RE: OAKLAND MEADOWS SUBDIVISION (C-20/D043)
Engineers Certification for Release of Financial Guaranty
Engineers Stamp dated 04/02/2003
Engineers Certification dated 07/06/2004

SUBJECT: OAKLAND MEADOWS SUBDIVISION (L31&32, B2, T3, U3 NAA)
CITY PROJECT NO. 710481 STORM SEWER LINE IN BARSTOW

SUBJECT: OAKLAND MEADOWS SUBDIVISION (L31&32, B2, T3, U3 NAA)
CITY PROJECT NO. 710481 STORM SEWER LINE MODIFICATION

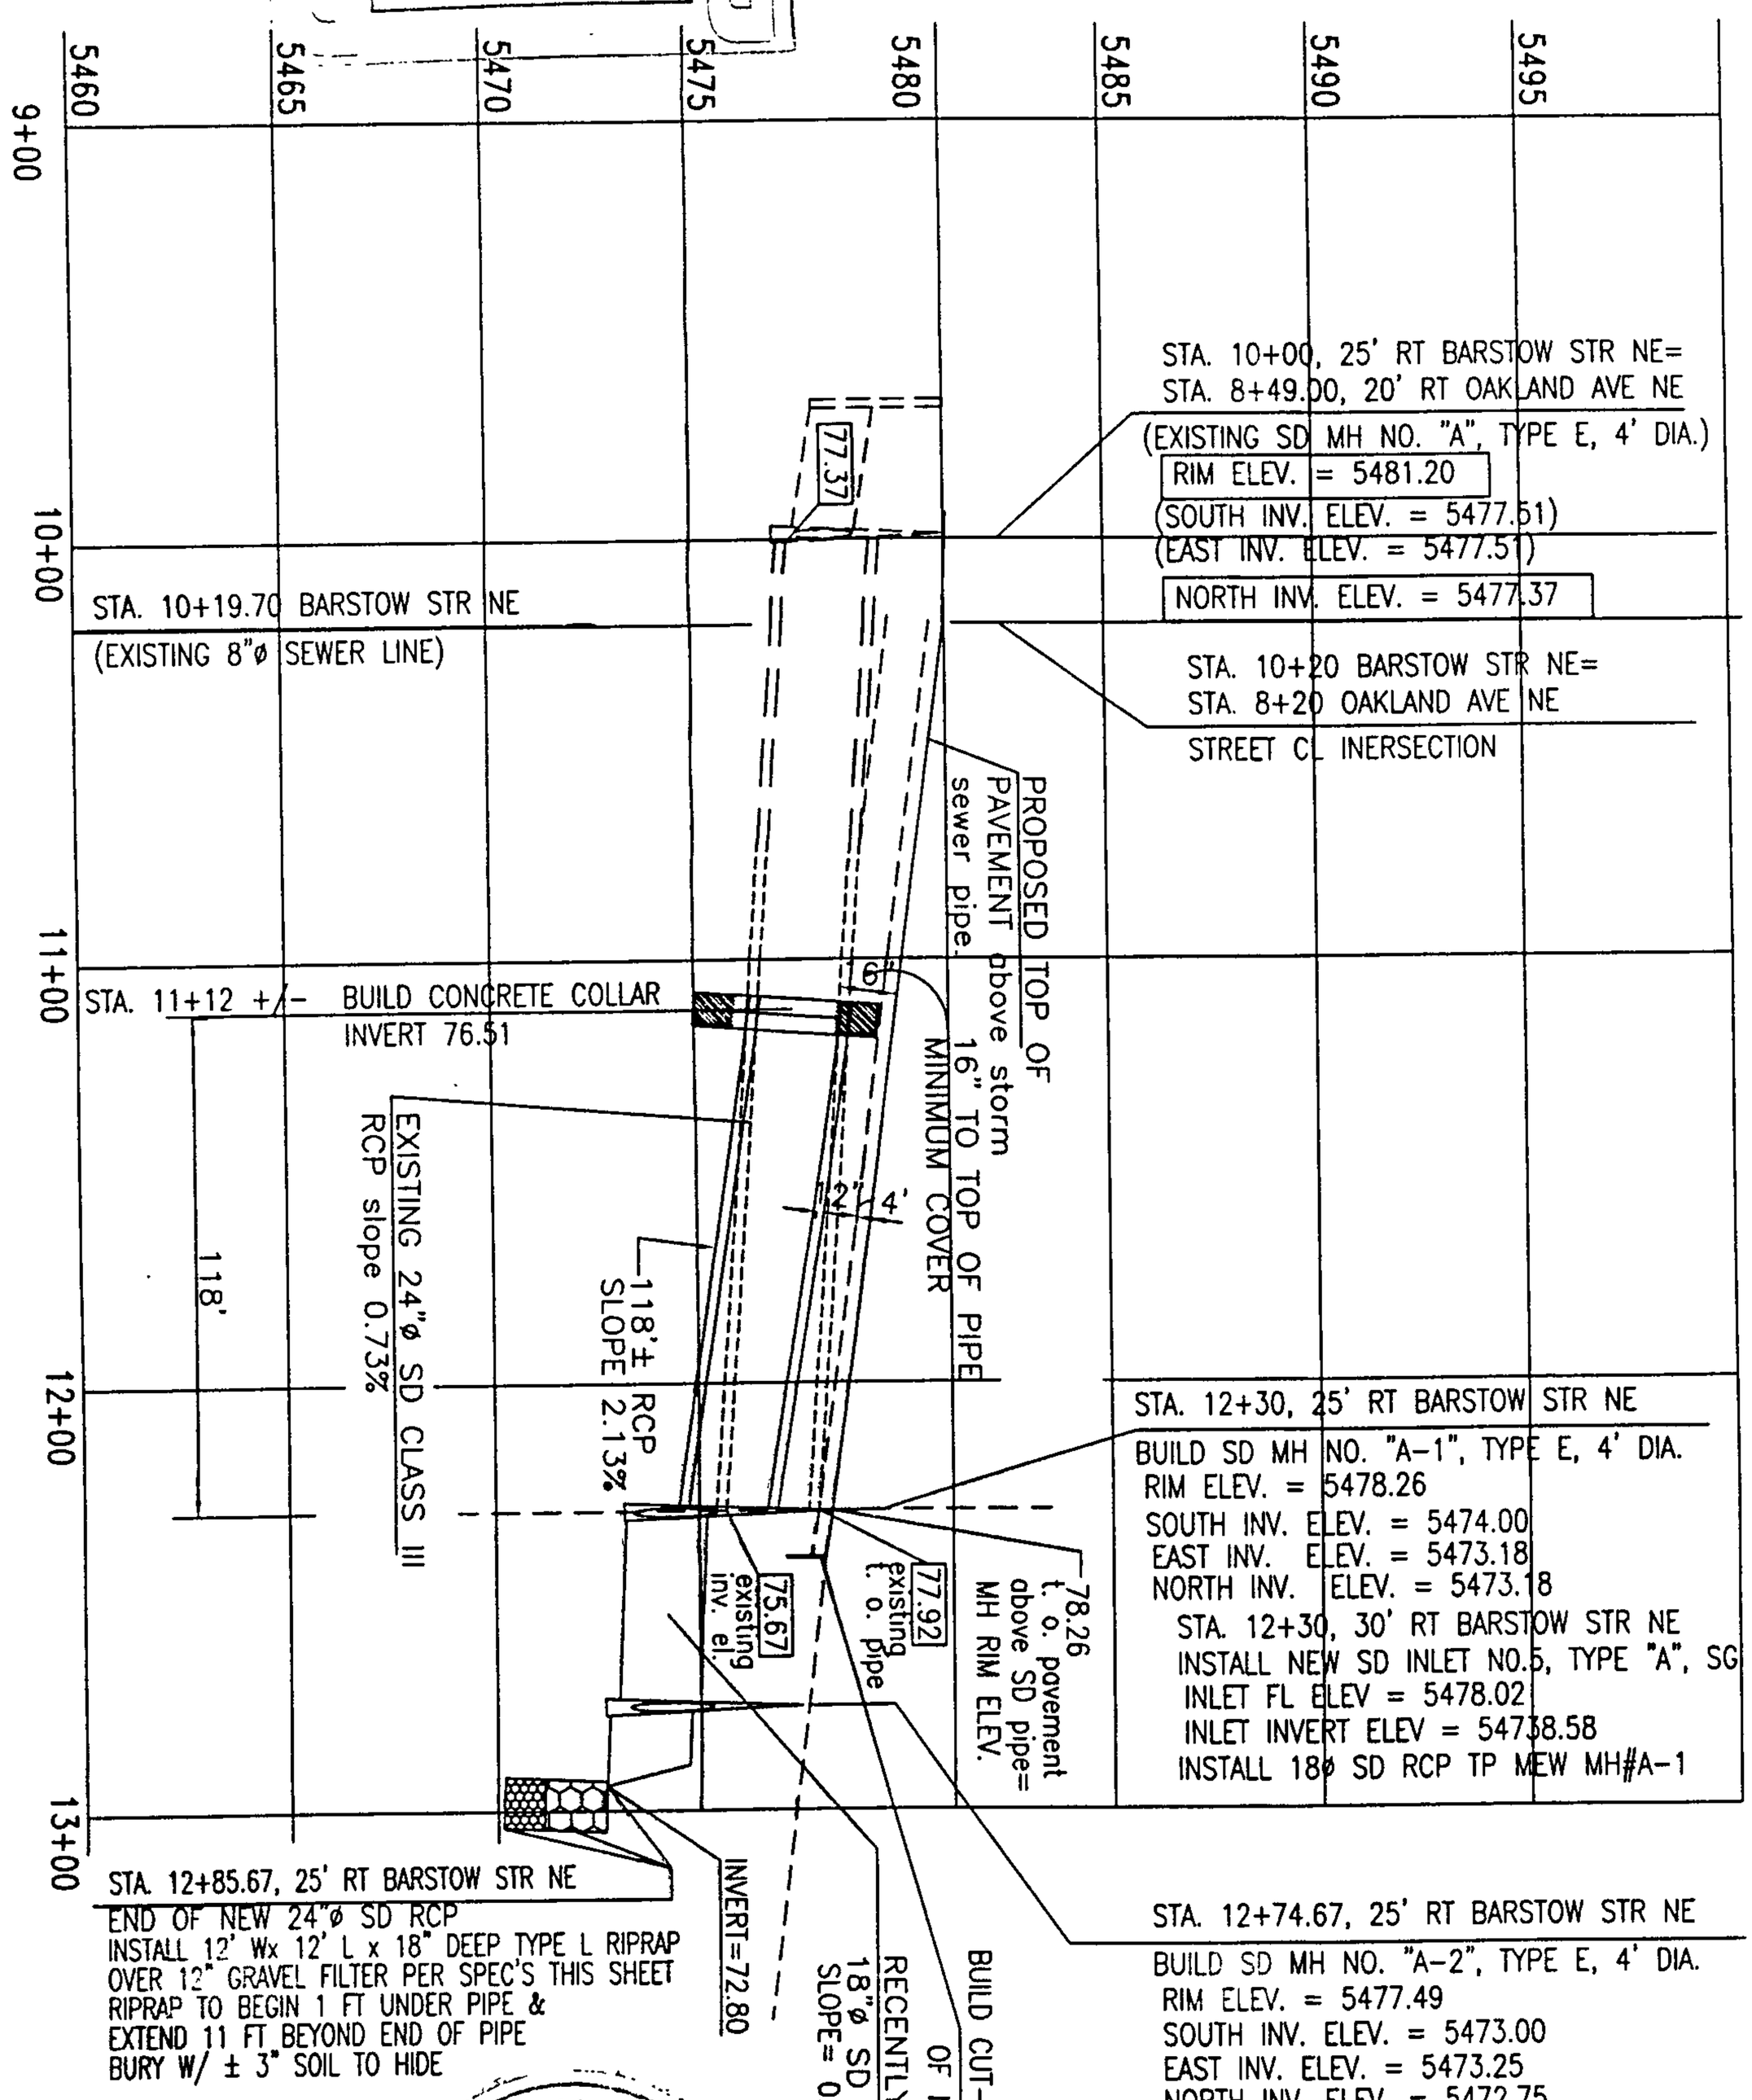
Pursuant to RHOMBUS' discussions with City Engineer Richard Dourte, PE, concerning the proposed pavement over the shallow storm sewer line in Barstow, we have attached, for your review and approval, a print of the profile of the proposed vertical re-alignment of the existing 24" RCP Class III pipe.

As discussed, the shortened pipe removal/lowering scope will be possible by using a pavement half-crown (1% instead of the standard 2% full crown) on the east half of Barstow and by using an 8" thick concrete collar in lieu of a manhole at the start of the pipe lowering, per detail B.
